Port of Seattle

Please see attached Port of Seattle comments regarding the Boeing Isaacson Thompson: Draft Cleanup Action Plan and Agreed Order

November 19, 2024

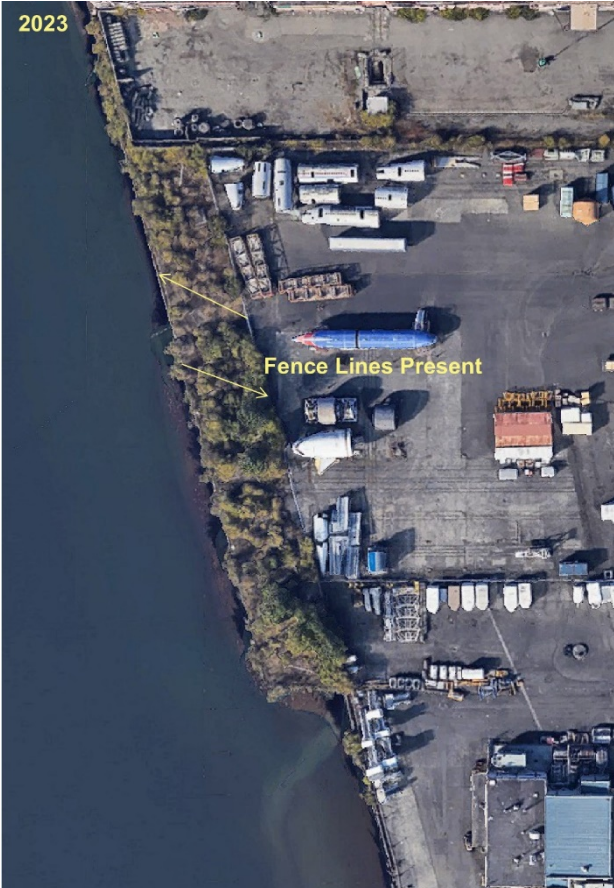
Comment	Section	Comment
1	dCAP Section 2.0	Update text to explain that the chain-link fence was installed between 1998 and 2002 based upon available imagery. See provided aerials from 1985 (USGS), 1998 (WA DNR), 2002 (Google Earth), and 2023 (Google Earth).

Comment	Section	Comment
<p>2002</p>  <p>Fence Lines Established</p>		<p>2023</p>  <p>Fence Lines Present</p>
